## River Deel (Crossmolina) Drainage Scheme

NIS Addendum

<b>Client</b>	<b>Office of Public Works</b>
<b>Project Title</b>	<b>River Deel (Crossmolina) Flood Relief Scheme – Environmental Services</b>
<b>Report Title</b>	<b>NIS Addendum</b>

TITLE  
**EXTENT OF SCOUR PROTECTION AT INTAKE**

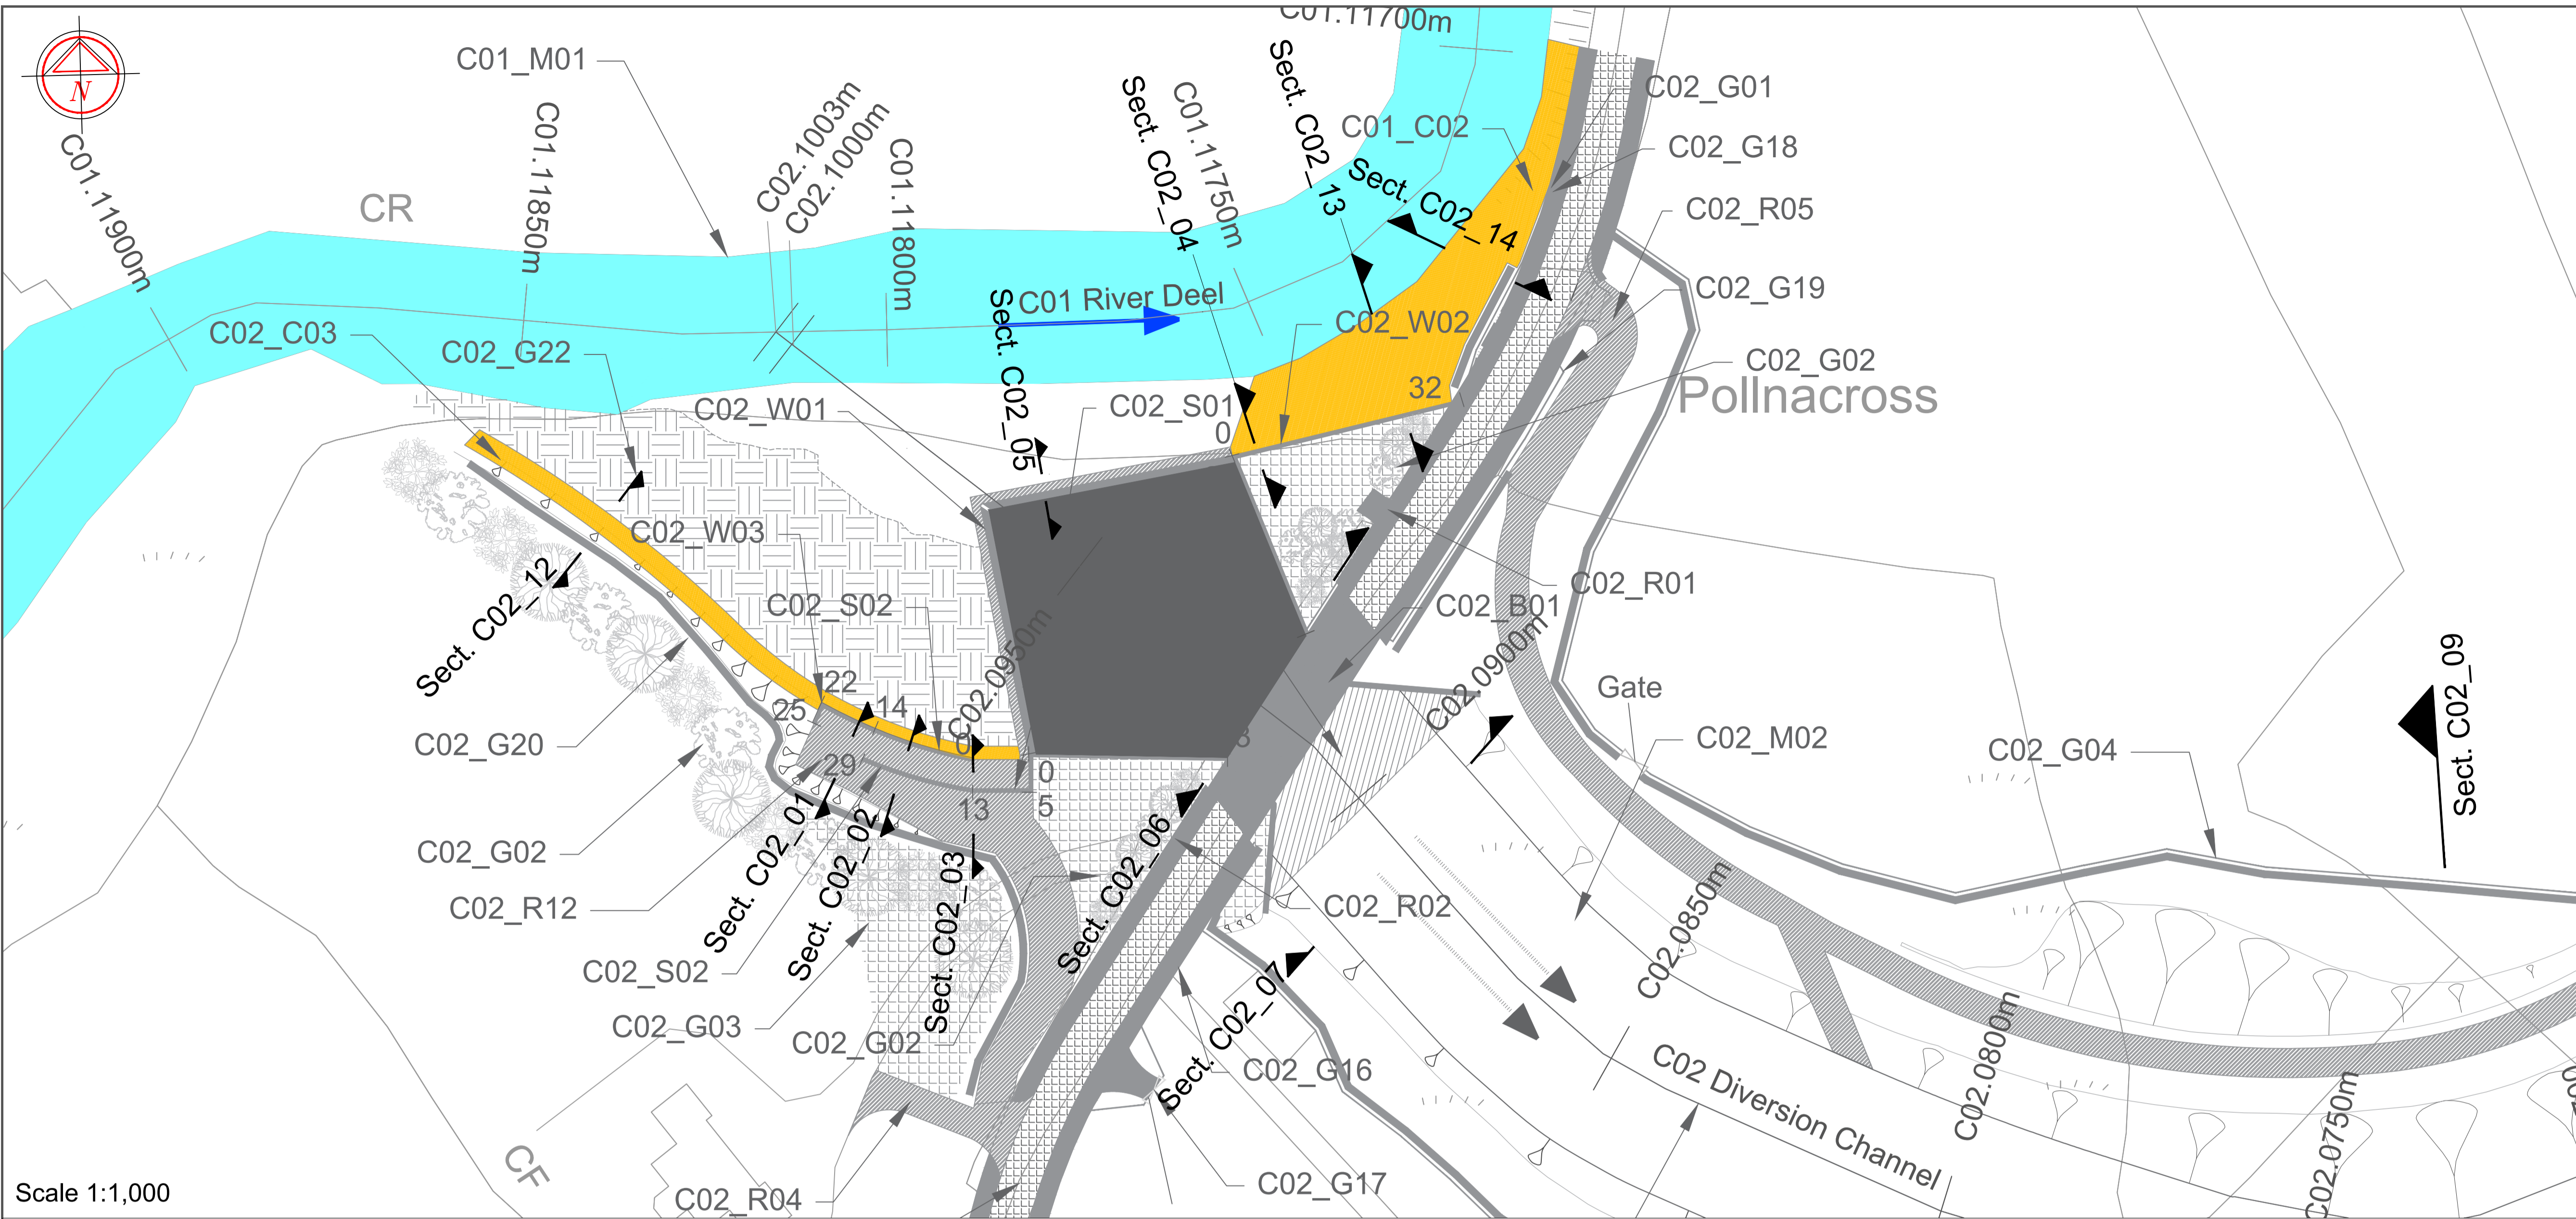
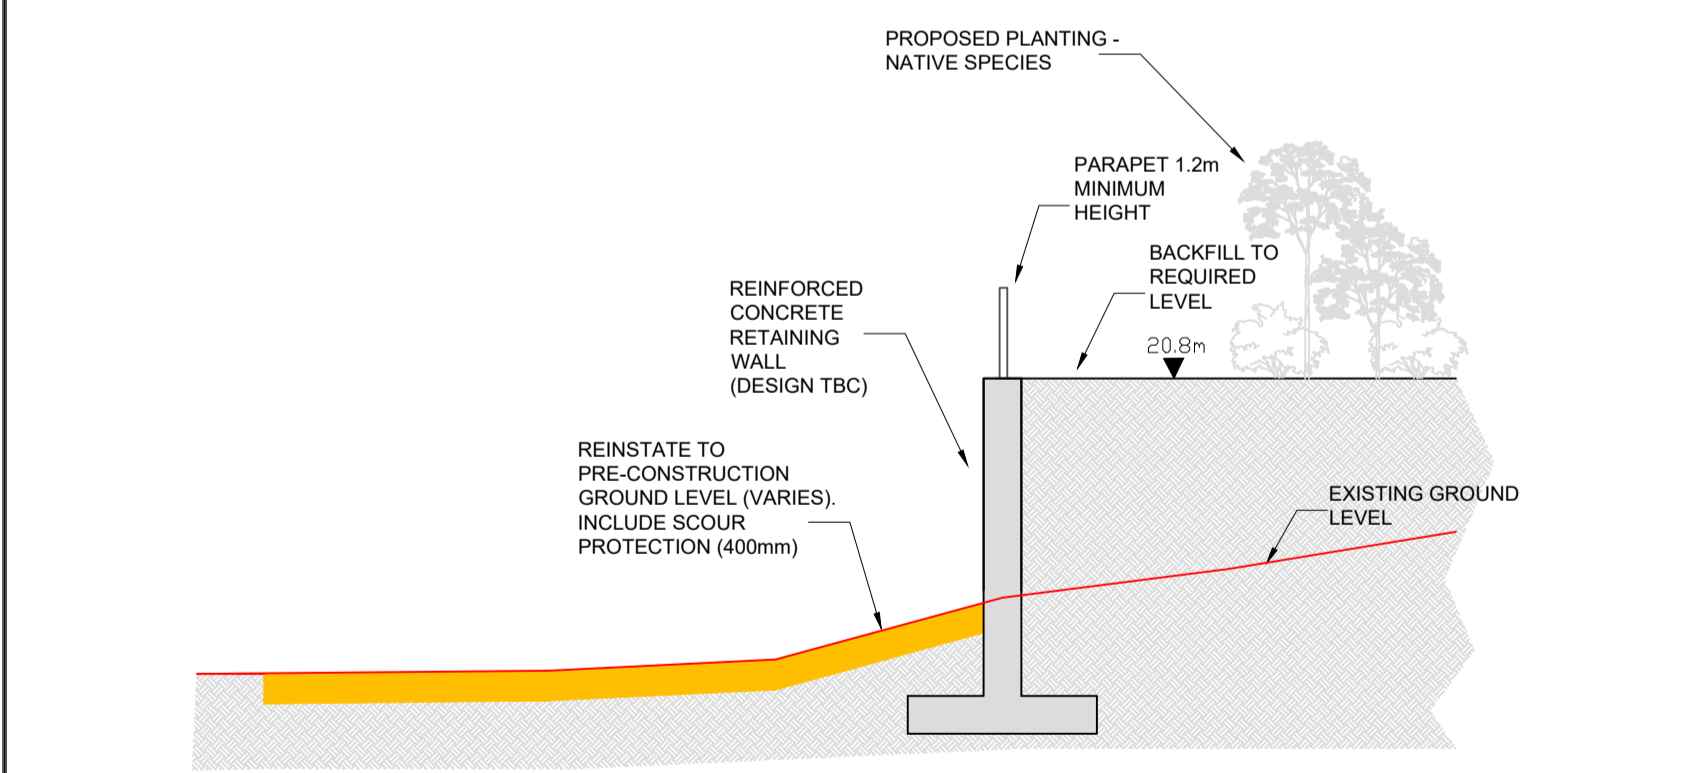
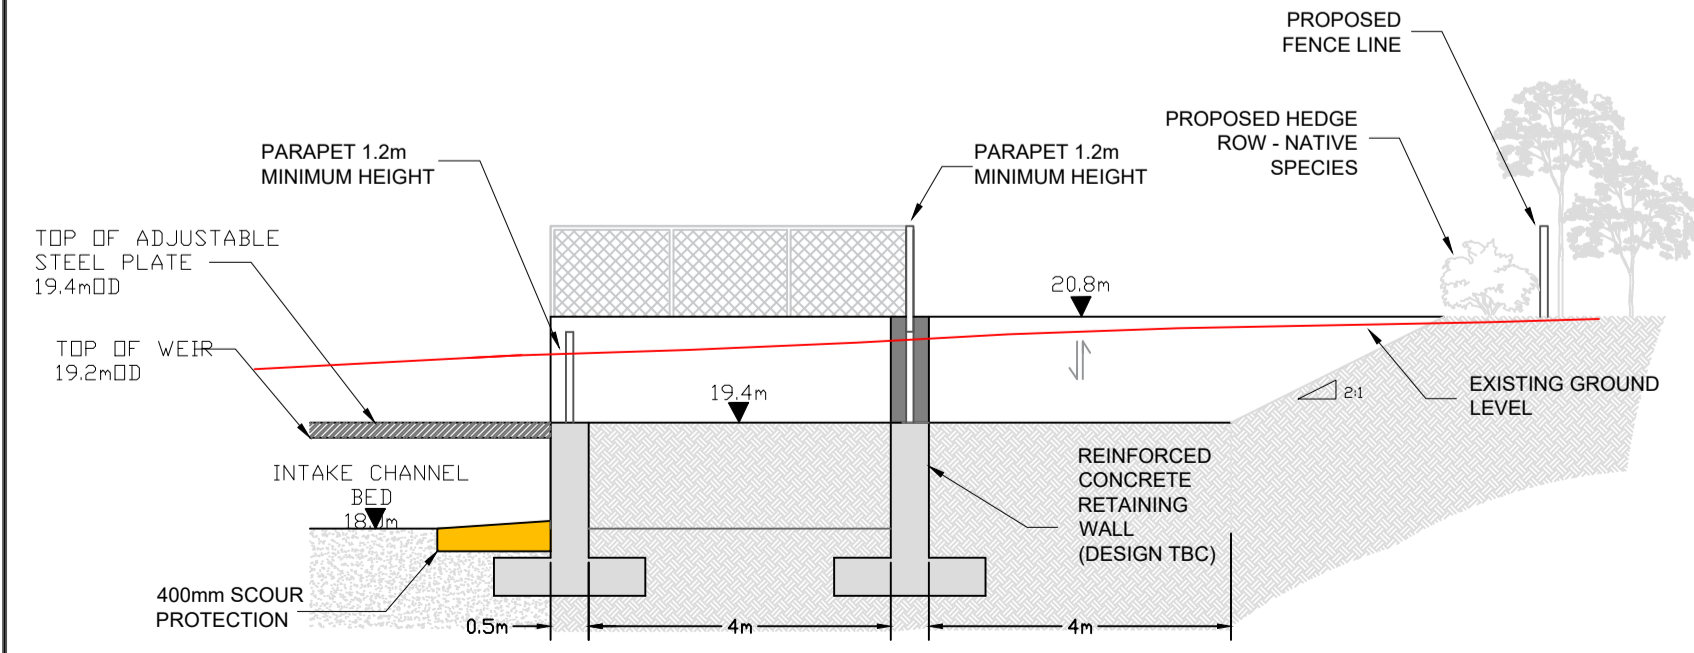
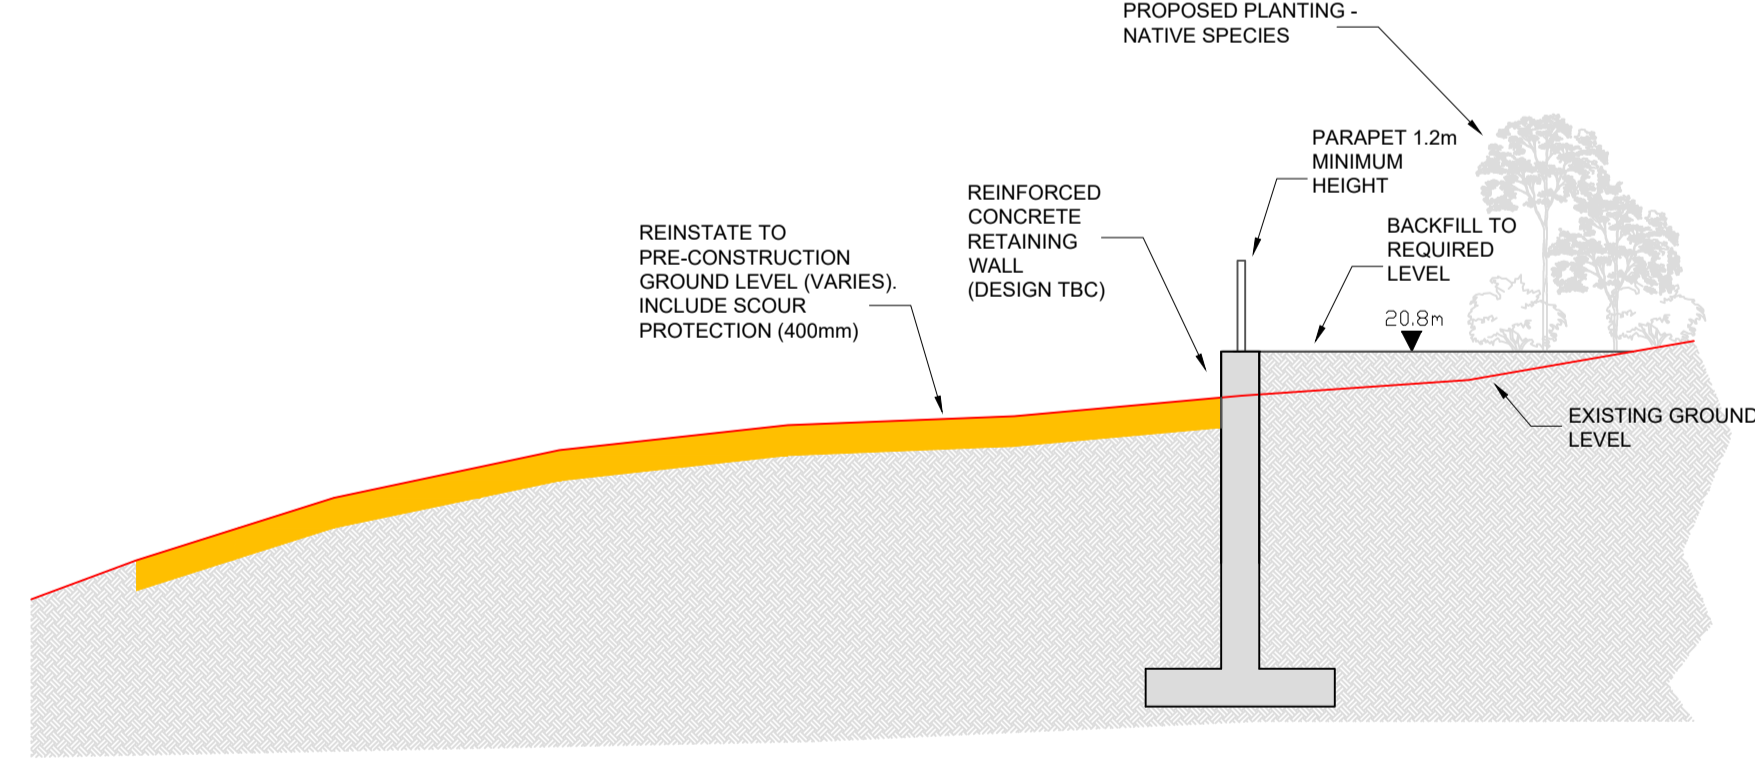
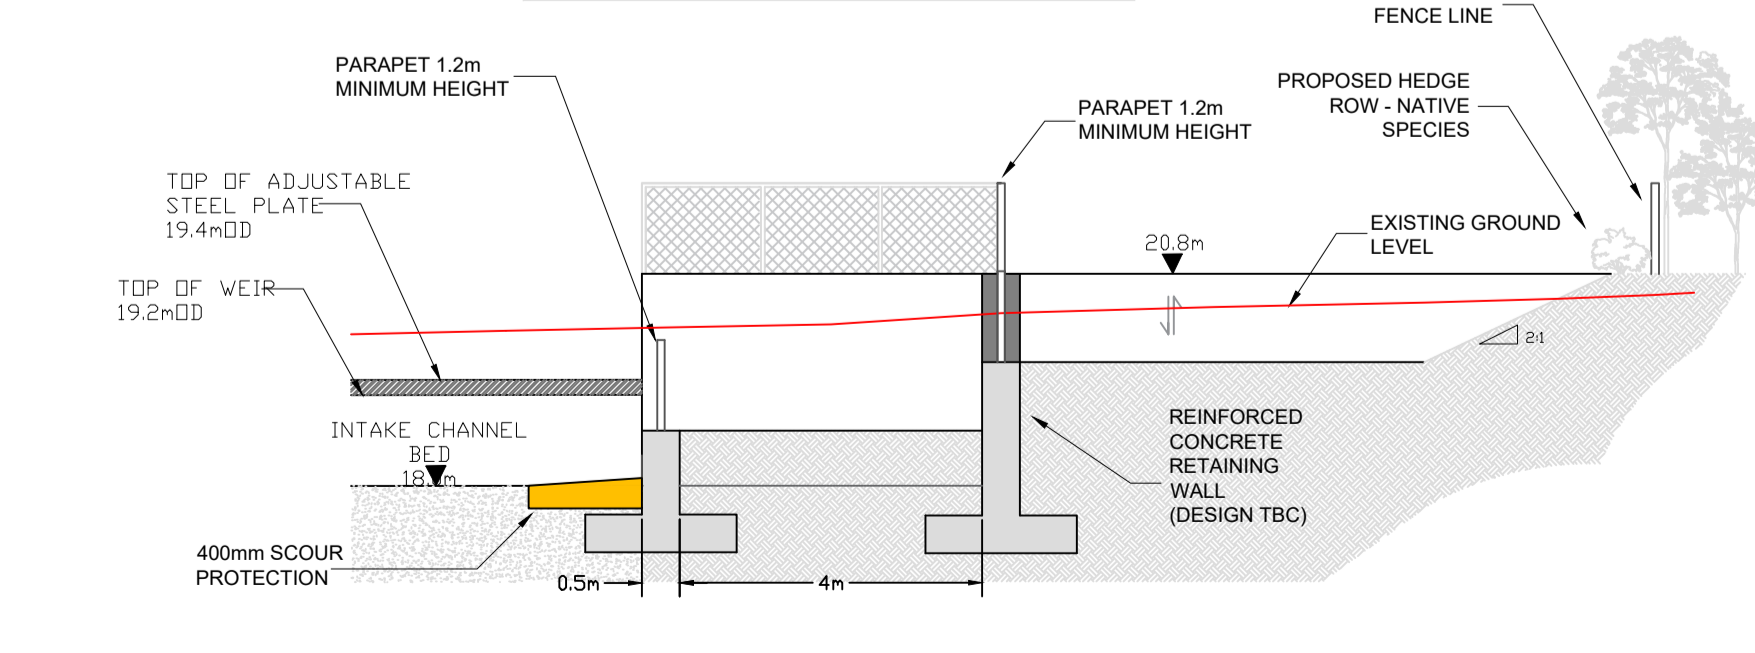
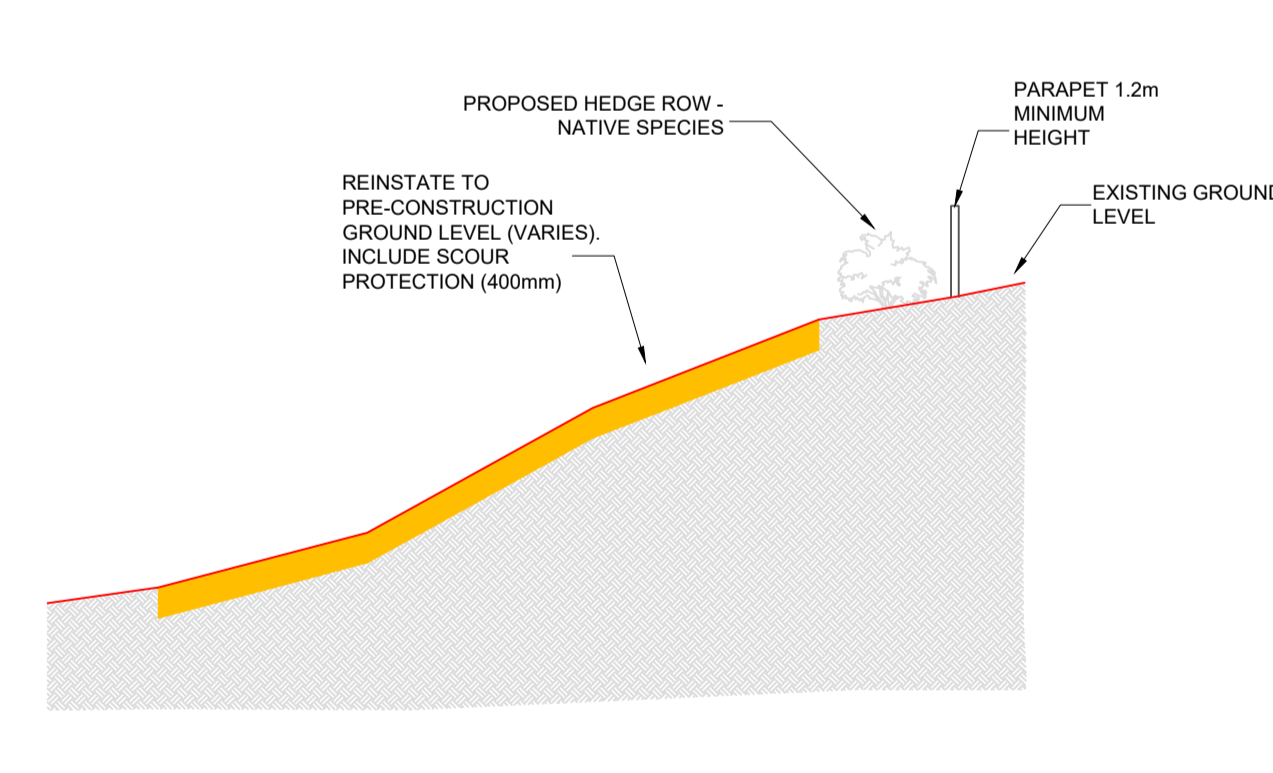
- Rock armour/ stone gabions will be placed in order to provide scour protection to the river banks upstream and downstream of the intake location as detailed in Appendix II (Drawings L\_01 and S\_01) and (Drawing SP\_01). This bank protection extends 90m upstream of the proposed intake structure and 80m downstream of the structure and will be undertaken by excavating on the bank and replacing the excavated material with rock armour or stone gabions.
